Road Safety Audit – B2132 Bilsham Road, Yapton

Stage: 2

Location: B2132 Bilsham Road, Yapton, West Sussex

Site: Proposed new development accesses

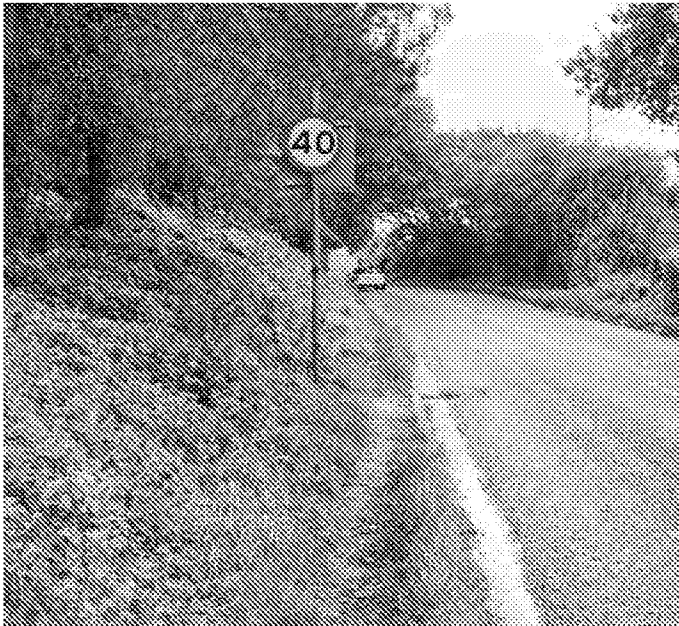
The existing Diagram Number 670 speed limit highway signage will be located within the proposed two-metre-wide footway to the allotments forcing pedestrians into the live carriageway placing them in conflict with motor vehicles.

Recommendation – Relocate the highway sign to the back edge of the footway or behind the footway.

A361-001 P1 - Proposed Access Arrangements

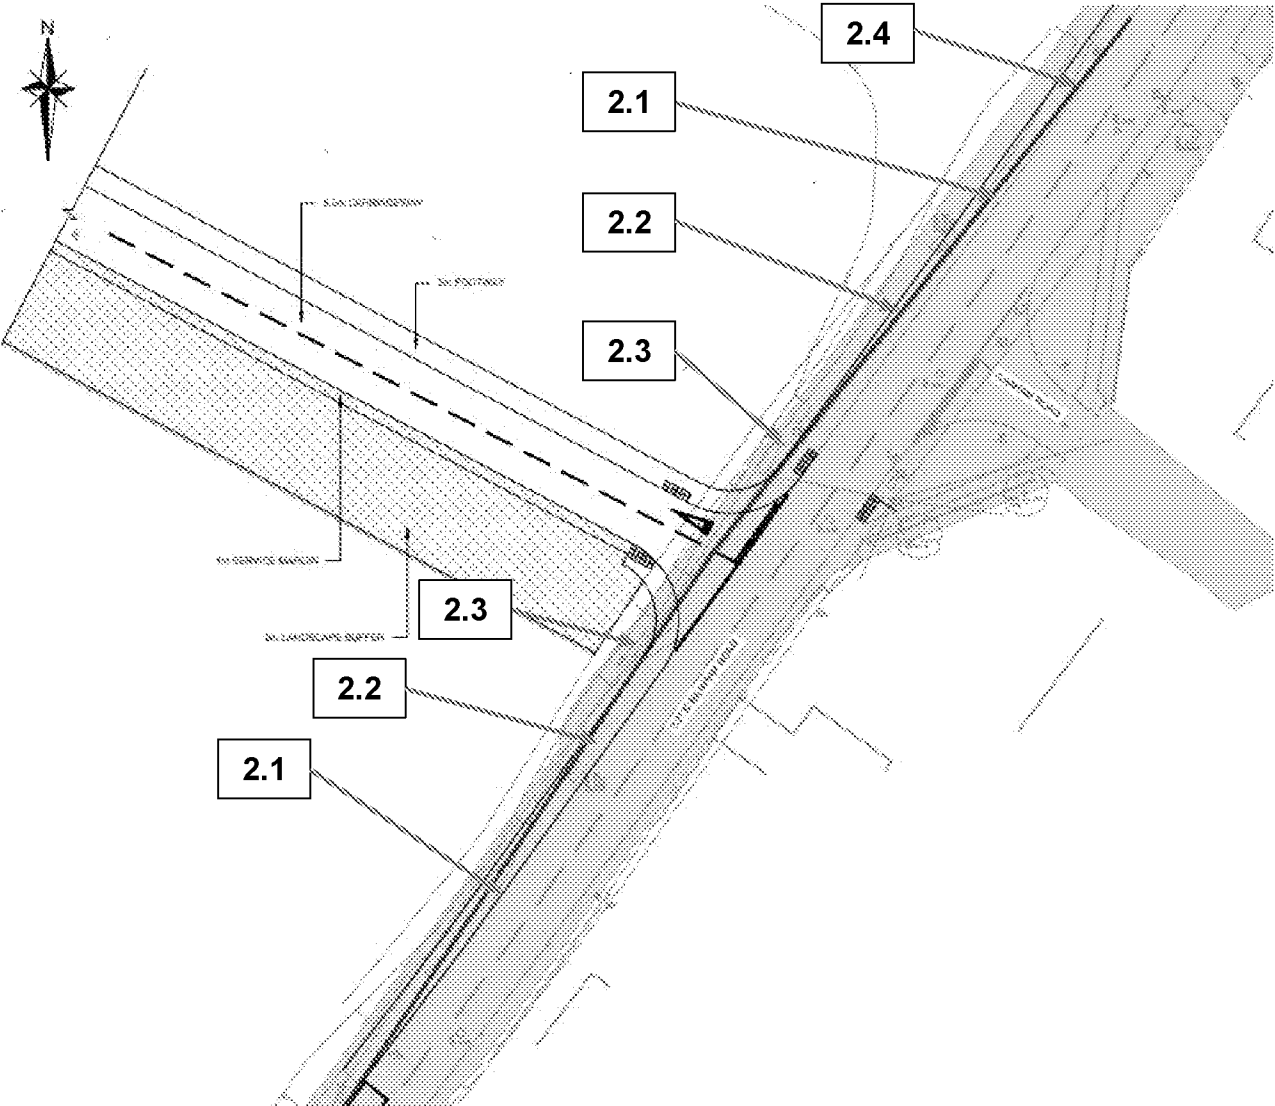
No footway construction details have been supplied to the Audit Team. Half-battered kerbs currently exist on the north-west side of the B2132 Bilsham Road increasing the risk of motor vehicles mounting the proposed footway and coming into conflict with vulnerable road users.

Lighting columns exist within the highway verge on the north-west side of the B2132 Bilsham Road which will be located within the proposed two-metre footway, reducing the effective width, forcing pedestrians into the live carriageway placing them in conflict with motor vehicles.

Vegetation to the rear of the proposed two-metre-wide footway on the north-west side of the B2132 Bilsham Road will obscure visibility to the left and right for drivers exiting the proposed priority junction onto the B2132 Bilsham Road, increasing the risk of failure to give way collisions.

No drainage details have been provided and there is evidence of ponding on the north side of the B2132 increasing the risk of loss of control collisions.

There is evidence of ponding on both sides of Taylors Close, in the vicinity of the proposed dropped kerb pedestrian crossing point, increasing the risk of pedestrian slips and falls.

An illuminated Diagram Number 602 'Give Way' highway sign and street naming plate exist on the south-west side of Taylors Close which will be located within the proposed two-metre-wide footway to the allotment, reducing the effective width of the footway, forcing pedestrians into the live carriageway placing them in conflict with motor vehicles.

The proposed dropped kerb pedestrian crossing across the bellmouth of Taylors Close makes the existing dropped kerb crossing point redundant. The existing dropped kerb on the south-west side of Taylors Close is currently being used by motor vehicles to access an off-street parking area to the rear of the footway, increasing the risk of conflict between vulnerable road users and motor vehicles.

Existing overhanging vegetation and scrub will obstruct the proposed two-metre-wide footway to the allotments forcing pedestrians into the live carriageway placing them in conflict with motor vehicles.

The vegetation to the left from the dropped kerb pedestrian crossing point proposed to be constructed across the B2132, south-west of its priority junction with Taylors Close, will obstruct inter-visibility between vulnerable road users and drivers, increasing the risk of conflict between the two users.

No footway construction details have been supplied to the Audit Team. Half-battered kerbs currently exist on the south-east side of the B2132 Bilsham Road increasing the risk of motor vehicles mounting the proposed footway and coming into conflict with vulnerable road users.

Recommendation – Install HB2 type kerbs along the front edge of the proposed footway.

Recommendation – Relocate the existing lighting columns to the back edge of the footway or behind the footway.

Recommendation – Cut back the vegetation as part of an on-going planned maintenance regime or remove the vegetation.

Recommendation – Ensure that the carriageway is adequately drained.

Recommendation – Ensure that the carriageway is adequately drained.

Recommendation – Relocate the highway sign and street naming plate to the back edge of the footway or behind the footway.

Recommendation – Remove the existing tactile paving on both sides of Taylors Close and reinstate the existing dropped kerb crossing point with full height kerbs.

Recommendation – Cut back the vegetation as part of an on-going planned maintenance regime or remove the vegetation.

Recommendation – Cut back the vegetation as part of an on-going planned maintenance regime or remove the vegetation.

Recommendation – Install HB2 type kerbs along the front edge of the proposed footway.
